## Appendix A

### Internal Responses East Lothian Council

### **RE: Inch Cape Onshore Transmission Works: Request for landscape Scoping Opinion**

**PROPOSAL :** Scoping Opinion under Regulation 17(1) of the Town and Country Planning (Environmental Impact Assessment) (Scotland) Regulations 2017 for onshore Transmissions works.

Figure 1. Copy of 17/00008/PAN which only show the redline boundary of the application site, as the power station has been demolished.

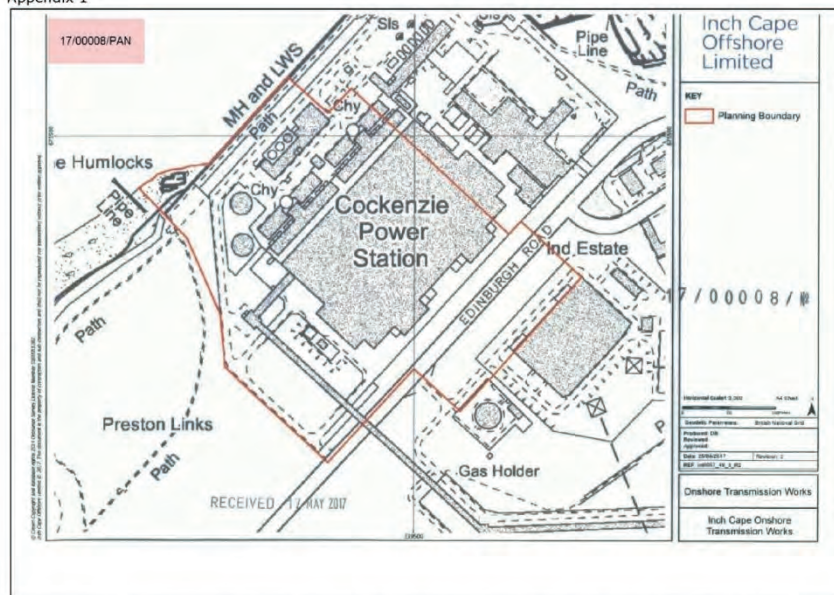
The applicant submitted application 17/00008/PAN for planning permission in principle for the construction, operation and decommissioning of an onshore substation, underground electricity cables and associated infrastructure required to export electricity from Inch Cape Offshore Limited's proposed offshore wind farm to the National Electricity Transmission System was submitted by Inch Cape Offshore Limited in May 2017, Appendix 1, Figure 5. The site is allocated in the proposed LDP 2016 for thermal generation. To the south of the application site, permission was granted 2/9/2014 for 14/00456/PPM Planning permission in principle for the construction, operation and decommissioning of an onshore substation, electricity cables and associated infrastructure required to export electricity from the proposed inch cape offshore wind farm to the national electricity transmission system for Land Adjacent To Cockenzie Power Station, Cockenzie, Prestonpans. Appendix 1, Figure 2 and 5.

Figure 3. Landscape designations adjacent to the application site, including Special landscape areas and Countryside around towns.

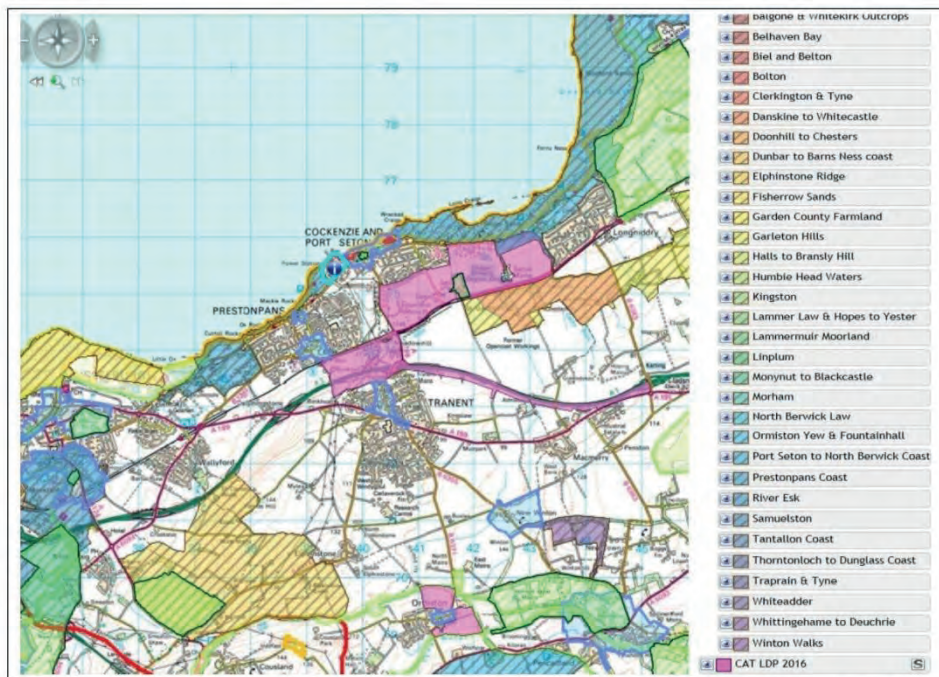
We require that any landscape and visual impact of the proposed development are assessed in relation to the proposed Special Landscape Areas (SLA) when preparing the LVIA.

There are ten documents with the title: Technical note 9, the list of SLA documents Appendix 1, Figures 3 and 4.
